Product Change Notification: PCN-22-143739

Terminal Contacts

Paper reel change from 999225-1 to 2400473-1

Paper reel appearance status 999225-1 & 2400473-1

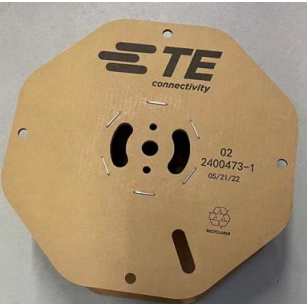
Reel part	Reel status	Fixed method	Different
995225-1	 		<ol style="list-style-type: none"> 1. No hole 2. Fixed of FIBER TAPE

1. Paper core status is different
2. Fixed method is different
3. Flag have small change, two side the circular hole change to the rectangle hole

Reel part	Reel status	Fixed method	Different
2400473-1	 		<ol style="list-style-type: none"> 1. Hole on the core 2. Fixed of core hole
